Product Change Notice (PCN)

PCN Number: PCN-0374166R-01

Product(s) Affected: CEP-2242

Additional Information:

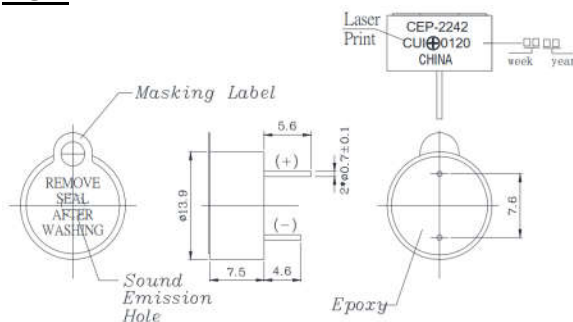
Description of Change: Form has been updated. Pin lengths have increased by .1mm and the diameter has increased .2mm. The height has decreased by .1mm. The sound hole masking label has been updated to cover the top of the buzzer. Function has increased to produce a min sound pressure level of 77dB and maximum current consumption has increased to 15mA. Operating voltage has also been updated to 4~16 VDC.
